Section 3 comments from Ballot on Draft Standard D2 (Vic Hayes, Chair, AT&T WCND)

Figure 3-5

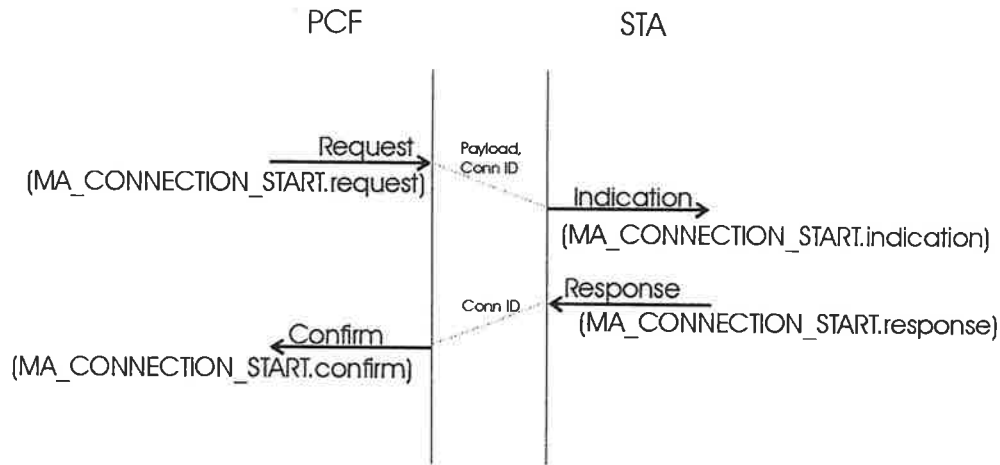
3.2.2	KJ	t	N	section is not complete	since scanning can be scanning can be initiated from outside the mac, and multiple APs could respond, a choice of APs is possible and an interface for this choice provided	
	<u>3.3</u>	<u>STh</u>	<u>T</u>	<u>N</u>		<u>Omitted from current draft; these drawing are from my notes on corrections needed</u>

Figure 3.5 shows the establishment of a connection-based association between a Point Coordination Function (typically an Access Point), and a STation. Note the connection ID (Conn ID) is established by the PCF, but is not passed to the LLC.

Figure 3-6

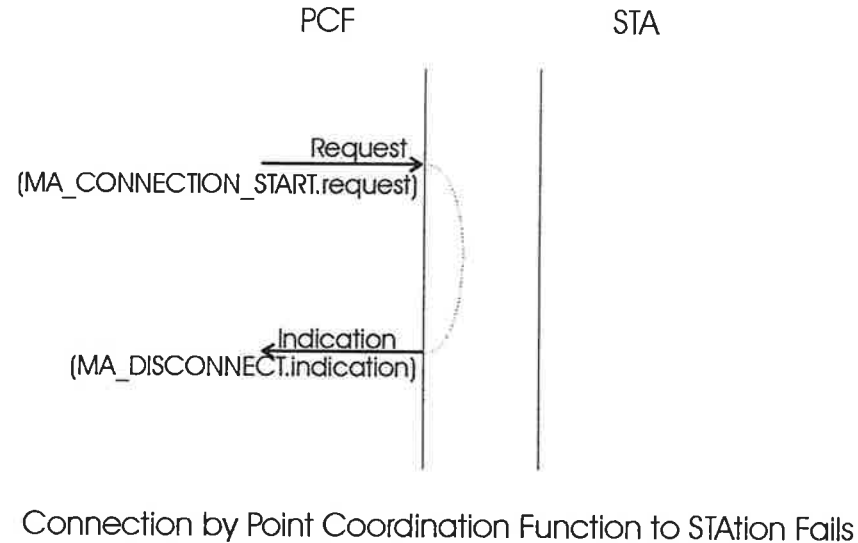
Figure 3-6 shows one possible failure condition for the establishment of a connection-based data transfer session. In this case the STation failed to respond or the MAC deemed that a connection was not possible, such as is the case during traffic congestion. If the STation had refused the connection, It would have generated a MA_DISCONNECT.request.

Figure 3-7

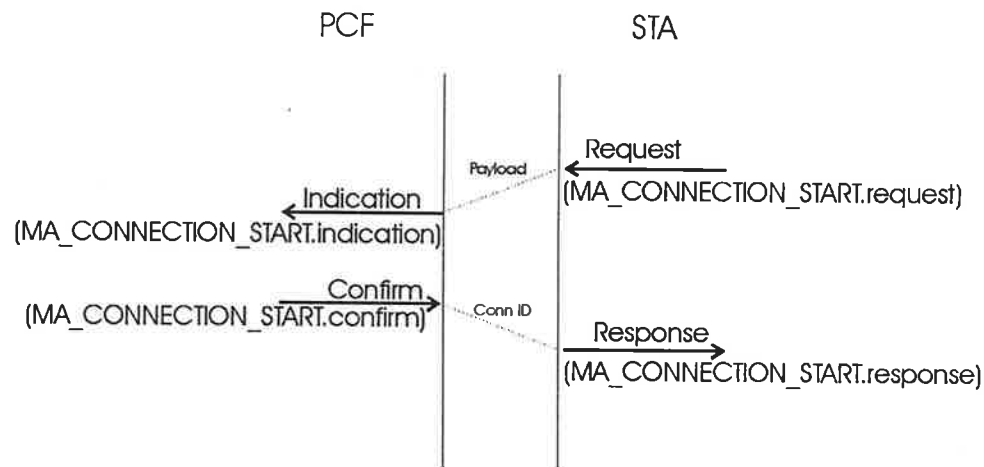
1. STA MAC user makes a Start Connection Request. If the STA MAC can support this connection then it generates a Start Connection Request frame (otherwise it will assert the Connection Not Granted Indication).
2. If the AP MAC believes that it can support this connection request then it will generate a Grant Connection frame and a Grant Connection Indication.

Figure 3-8

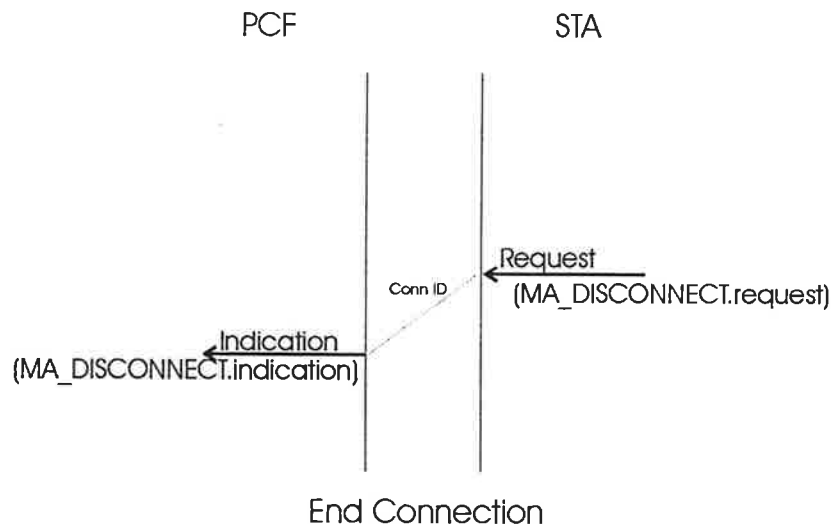
Either an PCF or a station may end a connection in the following way:

No MAC layer negotiation is needed to end a connection.
